6.1. NOTICE OF MOTION - MOSSMAN TOWN CENTRE STREETSCAPE UPGRADES

NOTICE OF MOTION:

Figure 7.4 Requirements for fence barriers at batters and vertical drops

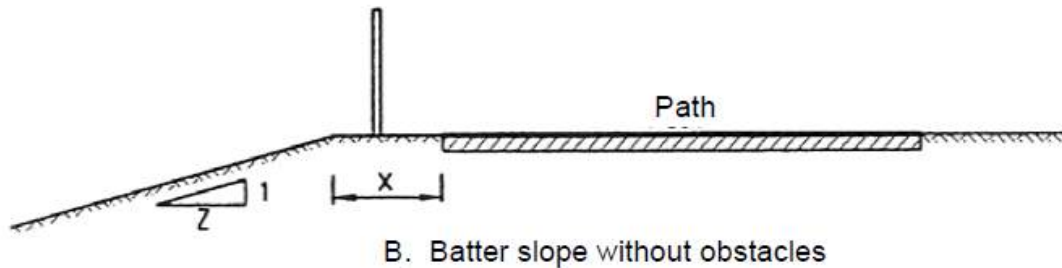
Figure 7.4 provides a specific recommendation for the provision of a fence on a path in close proximity to a steep batter or vertical drop. In addition to those referred to in the figure, other circumstances may exist where it may be desirable to erect fences even if provision is not required by the figure (e.g. a curving path alignment, located in the vicinity of batters or a drop-off, bridges). Figure 7.4 highlights the circumstances in which either a partial barrier fence (refer to Figure 7.5), or a full barrier fence (refer to Figure 7.6) or equivalent form of protection should be used. These barriers are intended to prevent access to a slope or to a fall away from a path or other riding surface, where injury might otherwise be expected in the event of a cyclist riding inadvertently off the line of a path.

Similar or even more stringent measures may be required adjacent to roads. Where a batter or fall is located in close proximity to a road, designers should have regard for the requirements of Figure 7.4, particularly where no kerb exists at the edge of a road. However, the actual measures required should be decided upon with consideration of all road users and of the particular circumstances.

Given the existing infrastructure in the area and the batter slope of the existing table drain, a partial barrier fence is required along this path edge. Figure 7.5 shows the type of partial barrier required. The partial barrier also needs to be located approximately 0.5m off the edge of the path to ensure compliance with the current guide. The existing weldmesh fence does not comply with the current guide and should be removed and replaced.

Figure 7.5: Example of a partial barrier fence details

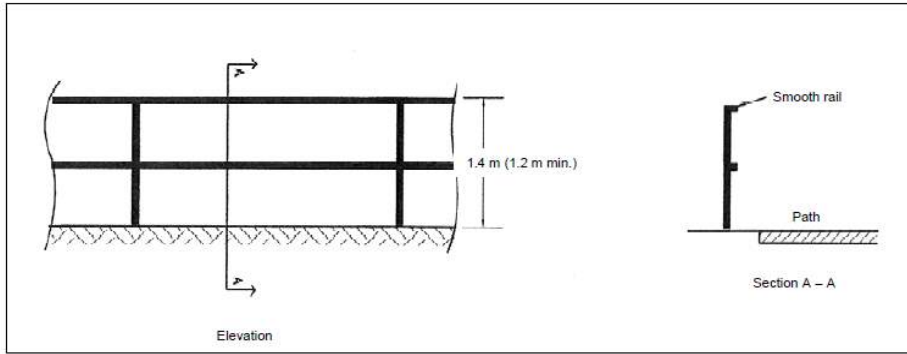
The proposal is to plant a hedge along this path and to remove the weldmesh fence. The design guide states that bushes and trees are considered obstacles. There is not sufficient room between the edge of the path and the top of the cut table drain batter to plant and hedge trees; and to maintain a 0.5m clearance. Additionally, the low retaining wall on the eastern side of the path and the timber power pole, it is not practical to realign the path away from the table drain.

Note: Desirable fence height is generally 1.4 m. Minimum of 1.2 m may be used where severity of hazard is considered to be low.
Source: Based Austroads (1999).

Figure 7.6: Example of a full barrier fence details

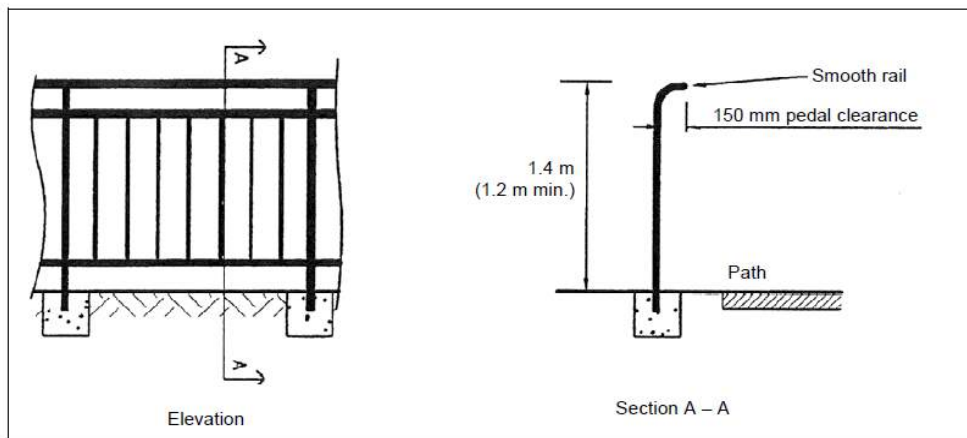
Note: Desirable fence height is generally 1.4 m. Minimum of 1.2 m may be used where severity of hazard is considered to be low.
Source: Austroads (1999).
